CITY OF CHICO MEMORANDUM

SUBJECT: Planning Commission Agenda Report Addendum for the Greenfield and Esplanade

Apartments, Use Permit 20-02

GREENFIELD +
ESPLANADE
MULTI-FAMILY
RESIDENCES

SITE PLAN

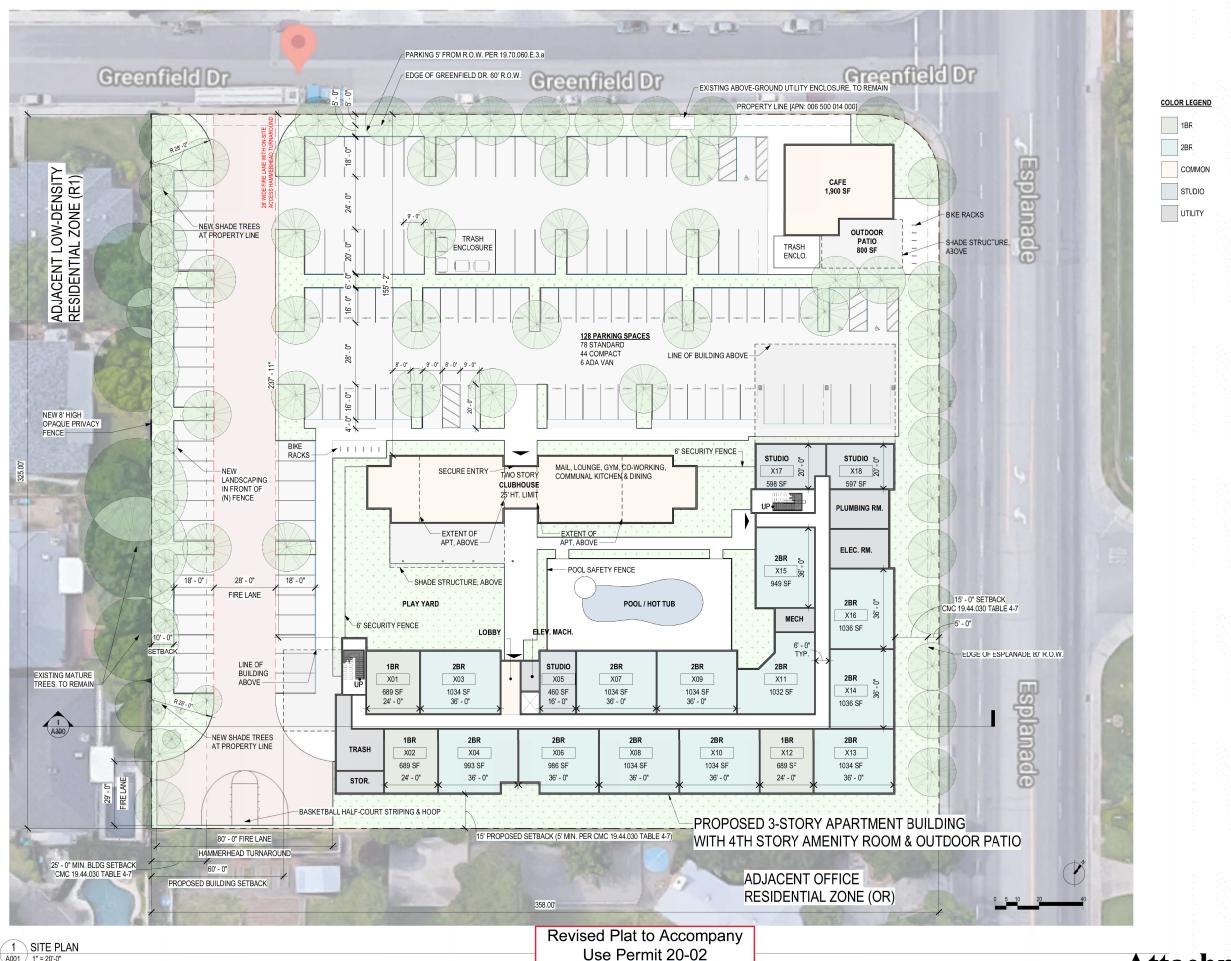
- 1. The revised draft site plan (**Attachment I**) shows the 5-foot City parkway strips contained within the right-of-way along Esplanade and Greenfield Drive, which were not shown on the previously provided site plan. The revised site plan replaces **Attachment D** of the Commission's Agenda Report. Adding the 5-foot parkways along these streets does result in physical changes to the plan along the Greenfield Drive frontage, now the 10-foot landscape buffer is a 5-foot landscape buffer behind the 5-foot parkway strip. However, along Esplanade, it shifts all of the improvements five feet westerly and reduces the landscape buffer along the rear property line from 15 feet to 10 feet. This shift reduces the apartment building's rear setback from 65 feet to 60 feet. The proposed 60-foot rear setback would still meet the City's objective standard of providing a minimum structural setback of 35 feet.

In conclusion, staff continues to recommend adoption of the findings contained in Planning Commission Resolution 20-14, and approval of the project subject to the recommended conditions, with a change to Condition #1 to make specific referce to the "<u>Revised</u>" Plat to Accompany Use Permit 20-02.
